11-0509-006-03
August 13, 2018

Re: **Responses to Engineering Review Comments - Corbin Block**

Corbin Block
Proposed Conditions - 50 Year Storm

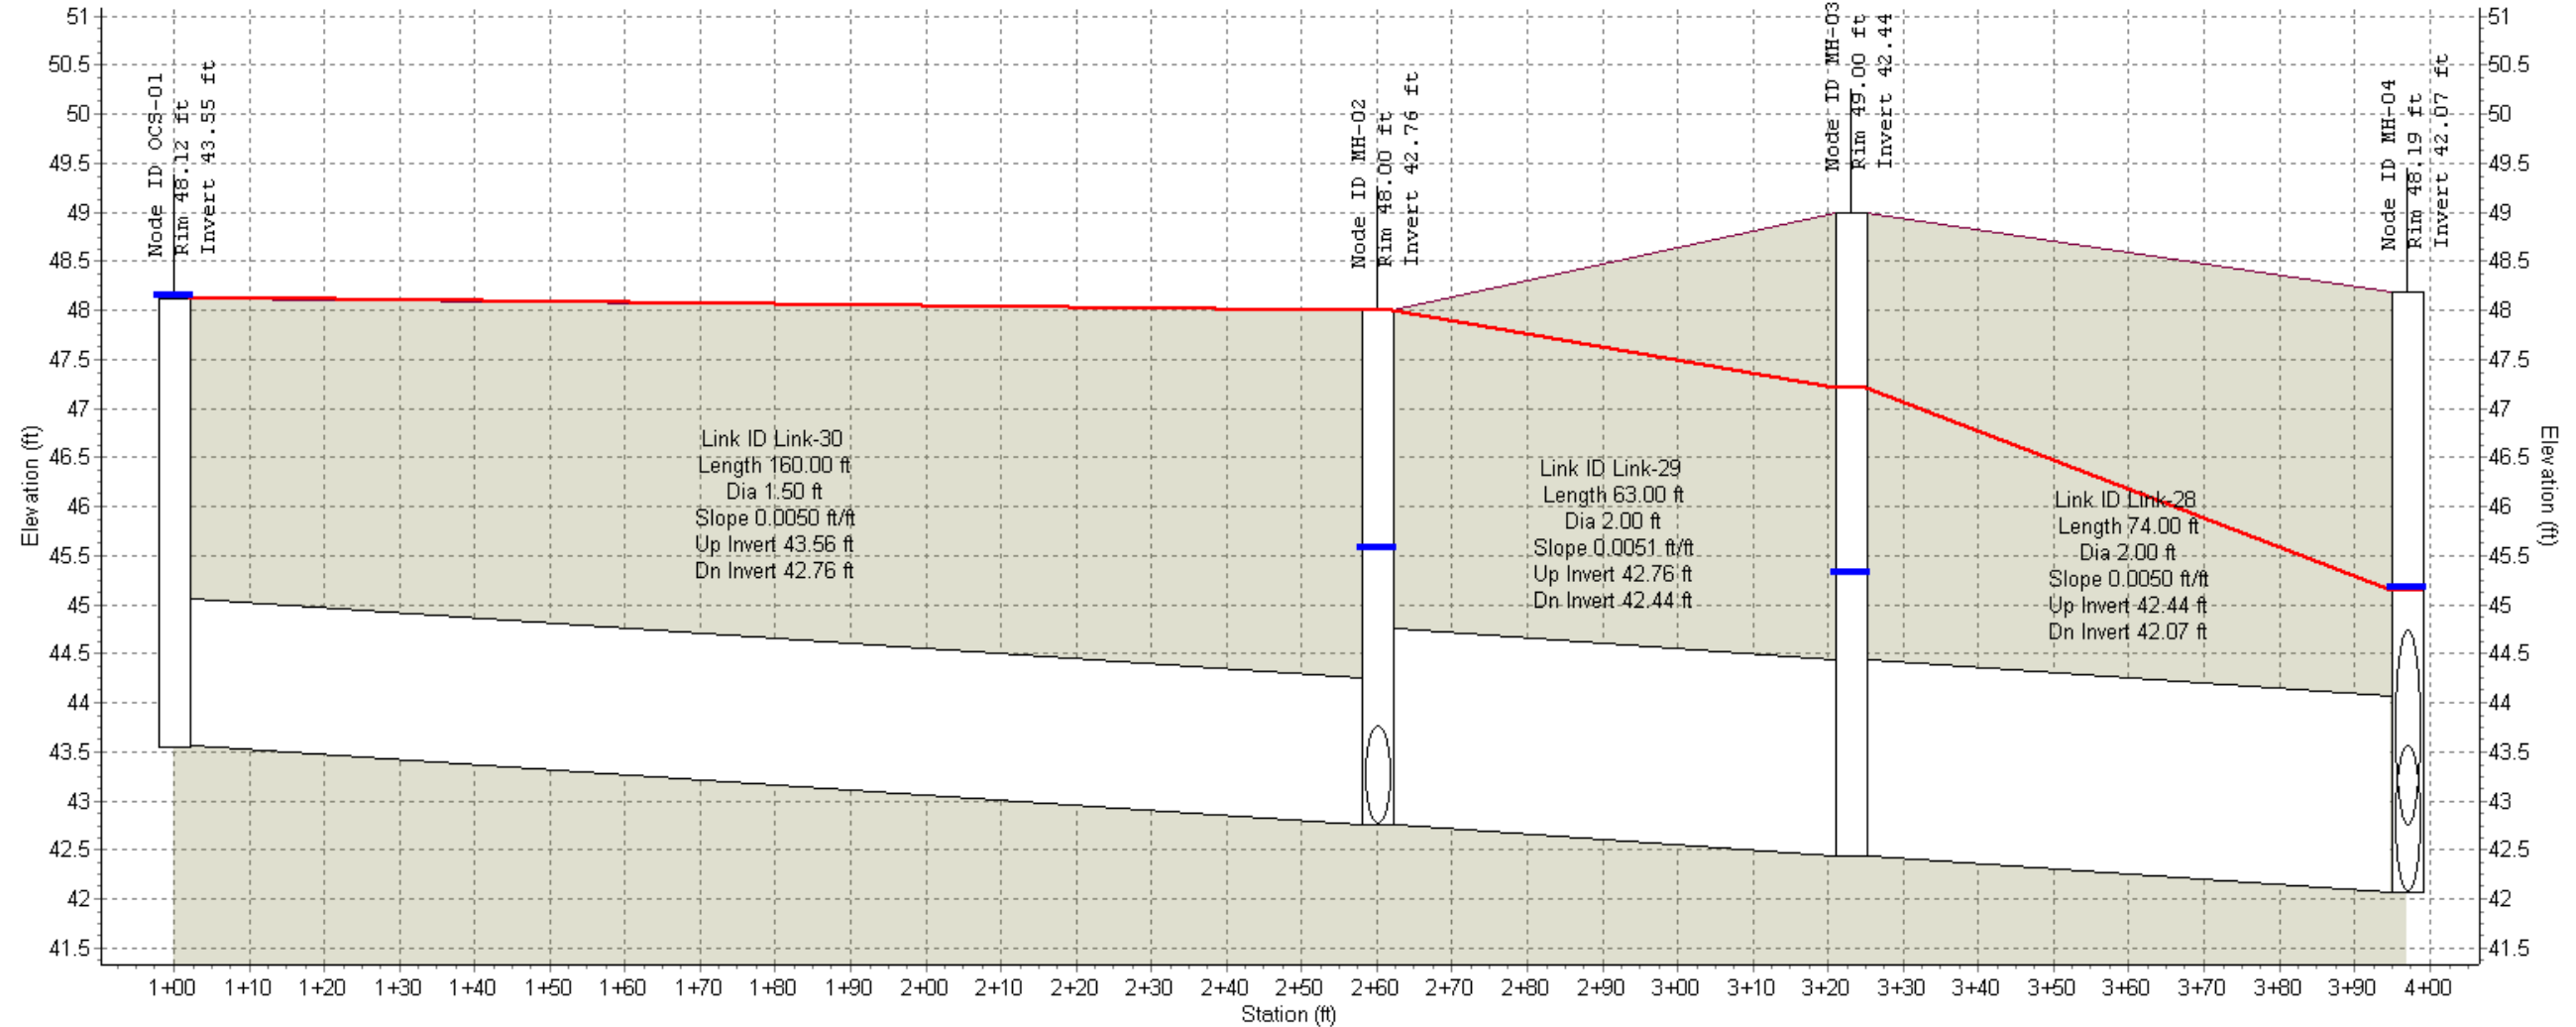
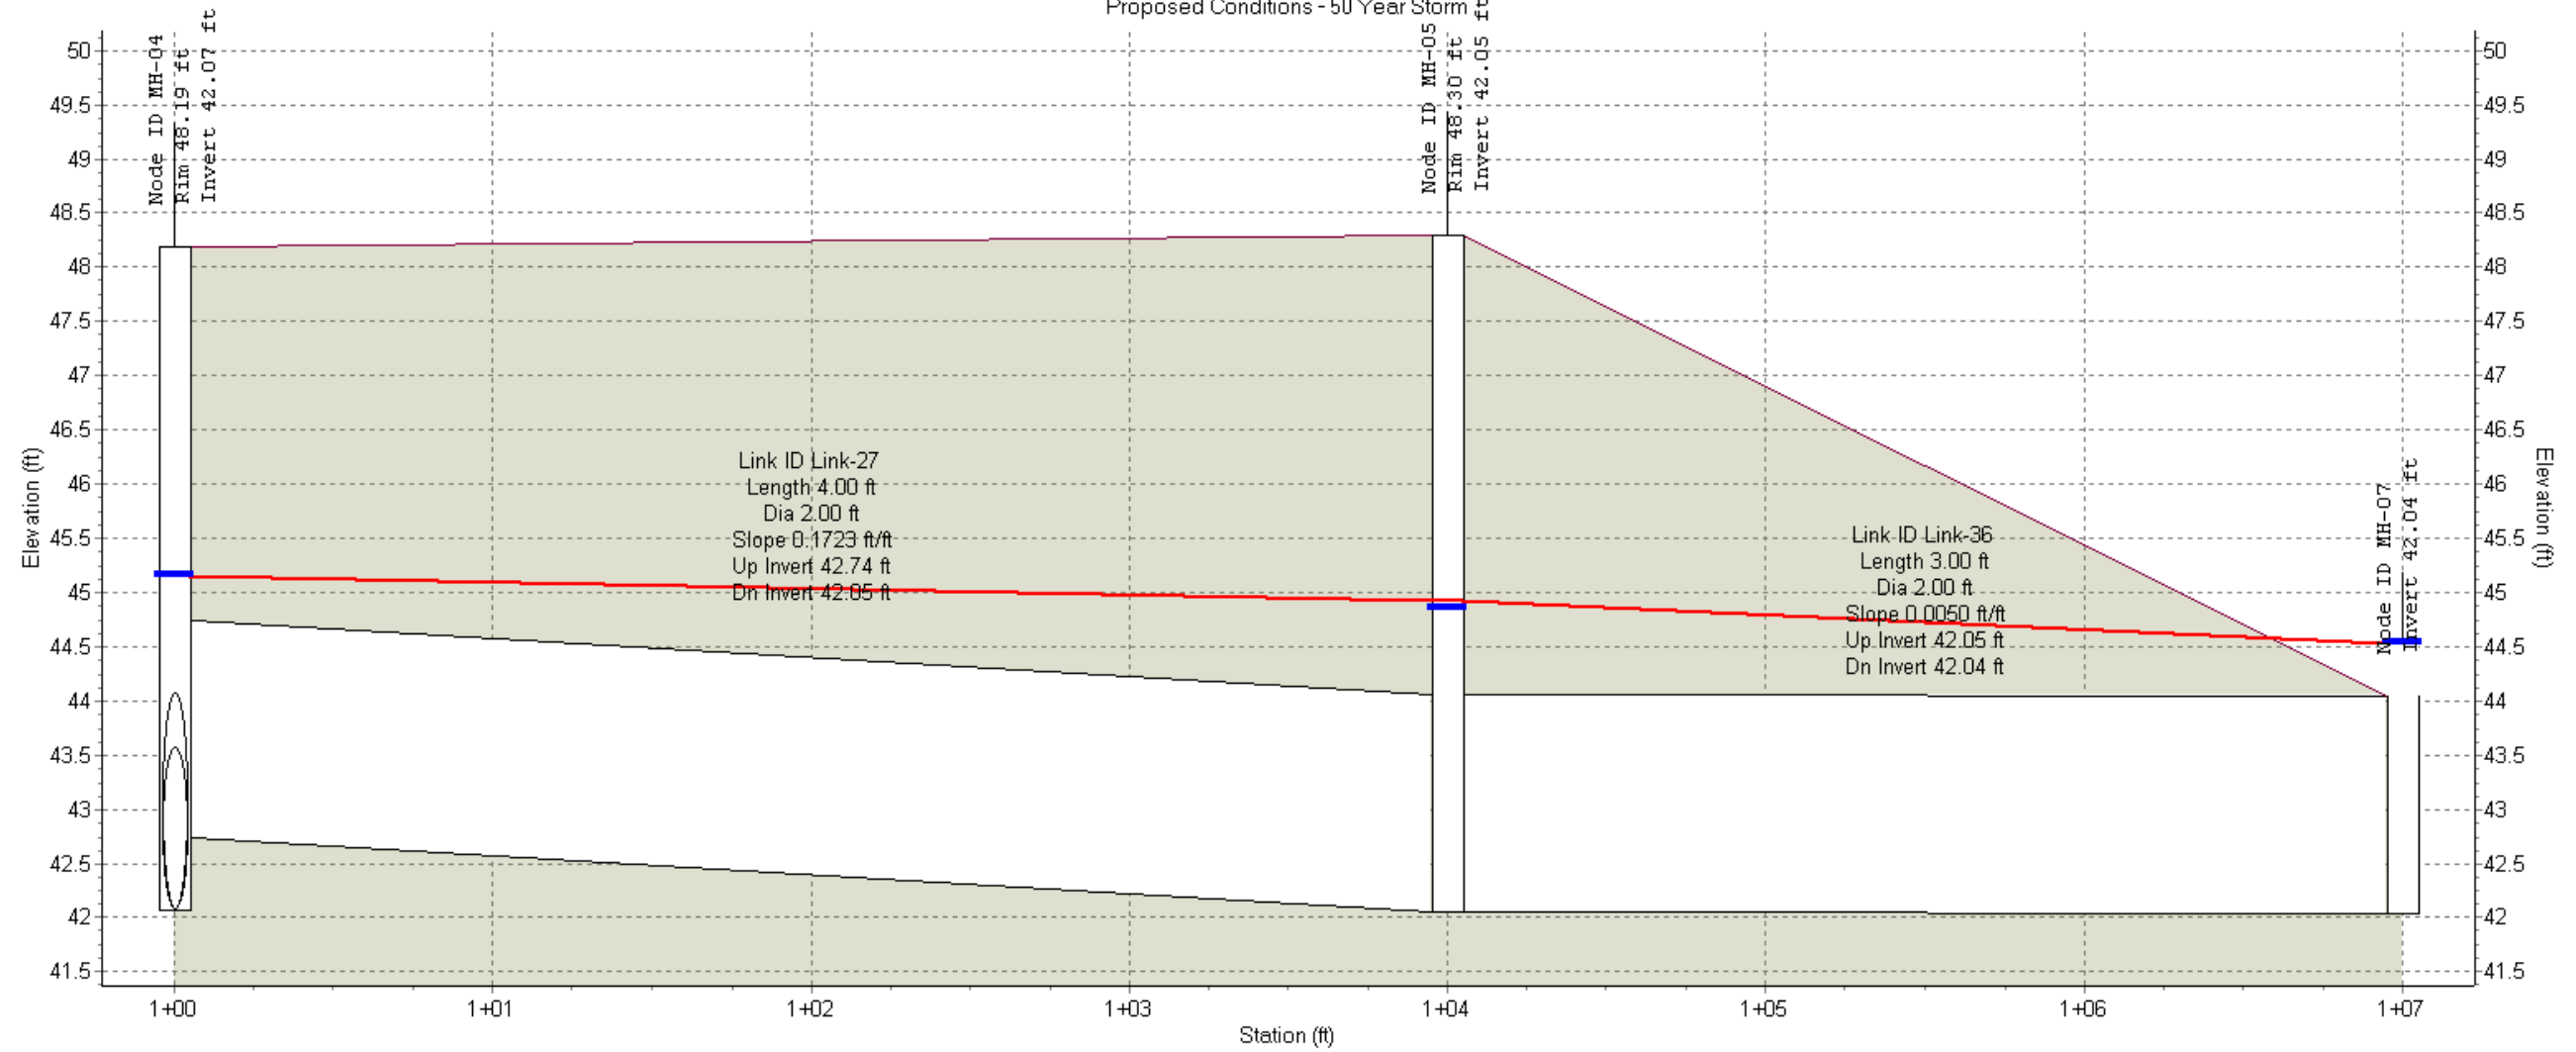
Update MH#7 in the 50-year HGL profile to have a tailwater equal to the 50-year peak water elevation of the south infiltration system (44.53). Take the maximum hydraulic grade line from the updated HGL model at OCS-01 and input it into the Hydraflow Model as the tailwater applied to the Courtyard Infiltration outlet structure. Provide the updated 50-year profile and updated 50-year Hydraflow Model to examine the performance of the Courtyard Infiltration system during a 50-year storm event. Update the drainage, if necessary, to make sure the Courtyard Infiltration system will function without surcharging to grade during the 50-year storm event. Resulting in flow reversals

We have also revised the HGL profile for the 50-year storm to reflect the starting tailwater elevation of 44.53 as requested. The revised profile has been included for your review. The revised profile indicates that the HGL will just crest at the frame of OCS-1 by 0.01-FT, but this is only very minor ponding that will likely be accommodated within the storage

capacity of the proposed trench drains within the plaza and not crest over the grate of the structure.
